CITY OF SMYRNA COMMUNITY DEVELOPMENT DEPARTMENT MEMORANDUM

Date: January 19, 2021

RE: **REZONING CASE Z19-019 – 2320 Campbell Rd**

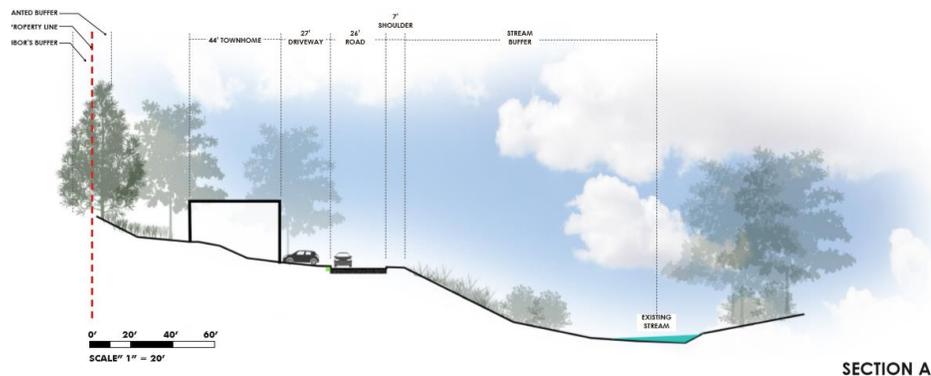
Section 1013.3 of the Zoning Ordinance requires a 10' landscape buffer between the subject property and all external property boundaries. The plan includes a 20' buffer from the adjoining single-family homes to the west and a 10' buffer from Argyle Elementary. Due to the location of the stream buffer a minimum 50' buffer is provided between the development and the homes along Woodruff Drive. Additionally, the property to the west is located at the top of a ridge line, with development of the subject property being in the slope below the ridge. The townhomes will be built into the hillside with only the top two-floors of the townhome being visible from the single-family homes to the west, and with a 20' planted landscape buffer between the single-family homes and the proposed townhomes. At the southern end of the development the ridge begins to flatten. The development will include 10 single-family detached units at the southern end to bring this section further into scale with the development to the west. The figure below

reflects a cross-section of the proposed landscape buffer, townhome, private road and a stream. The townhomes are shown to be setback 40' from the adjoining property line.

32. The developer shall be responsible for any stormwater improvements deemed necessary by the City Engineer.
33. The developer shall provide a 20' landscape buffer in accordance with Section 1013.3 of the Zoning Ordinance along the western property line and 10' along the Eastern property line.
